REVISIONS FOR PERMITTED PROJECTS

Received: _____ Date of Revision: 10/26/2020 Permit#: 20-3520

Project Name: Susan Baker

Type of Permit: DRIVEWAY

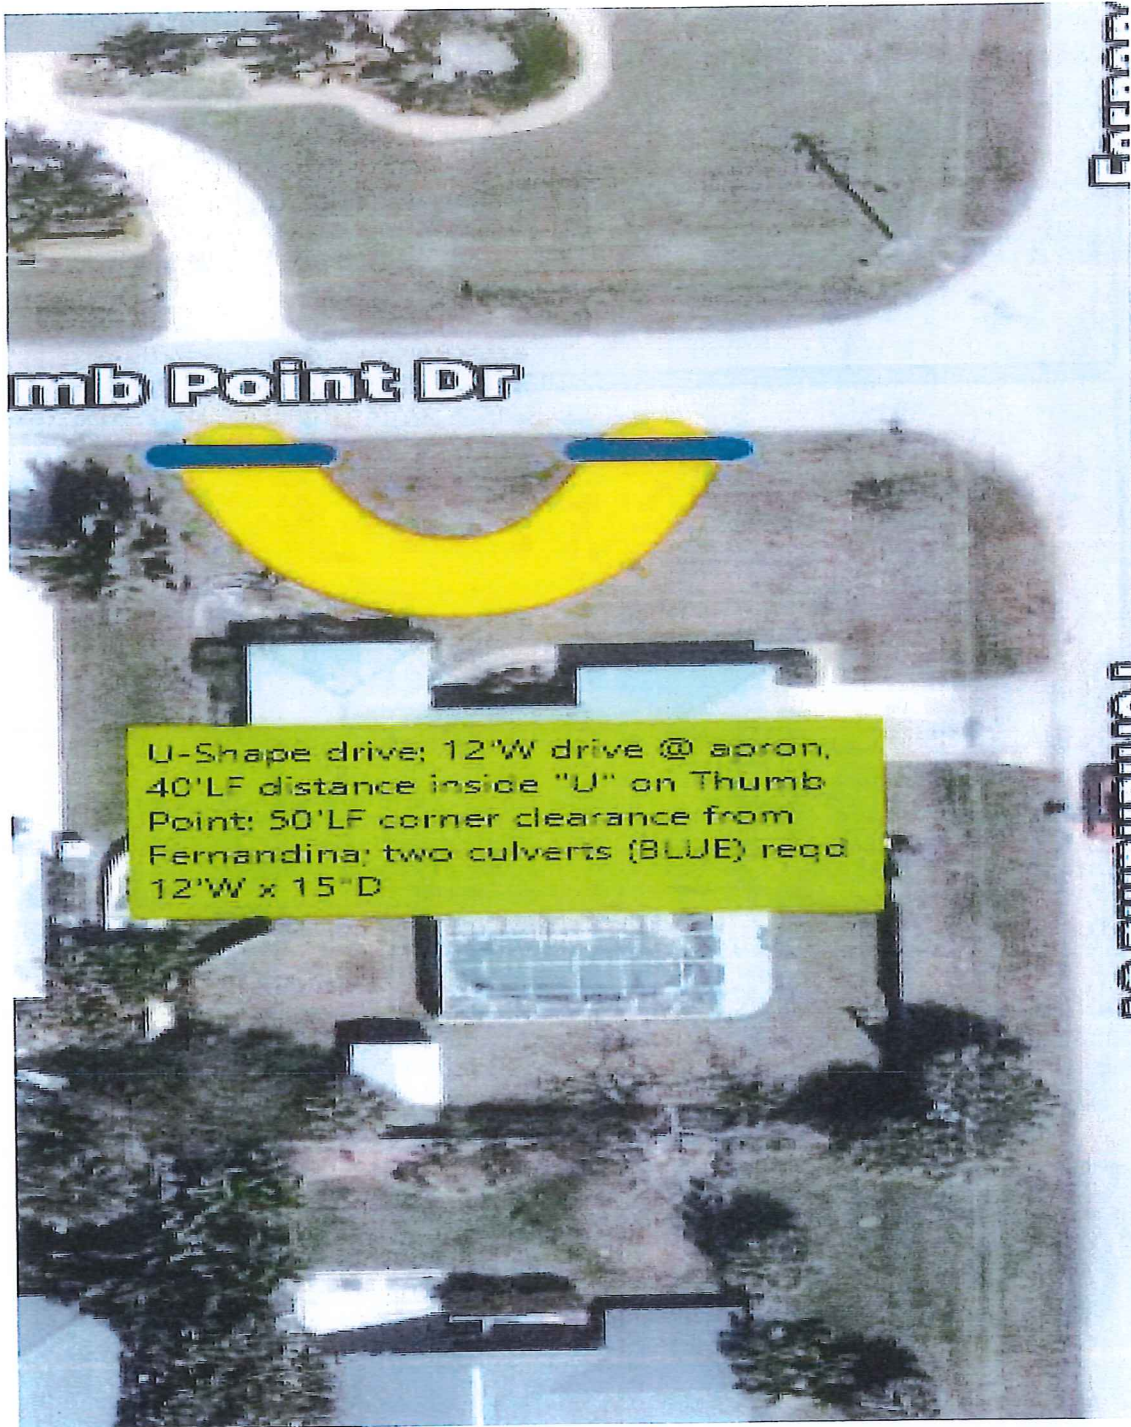
Detailed Description of Revision: **CHANGE IN VALUATION:** no

U-shape driveway 12"W @ apron 40"LF in distance inside the "U"

50 LF corner clearance from Fernandina; 2 culverts 12x15 d
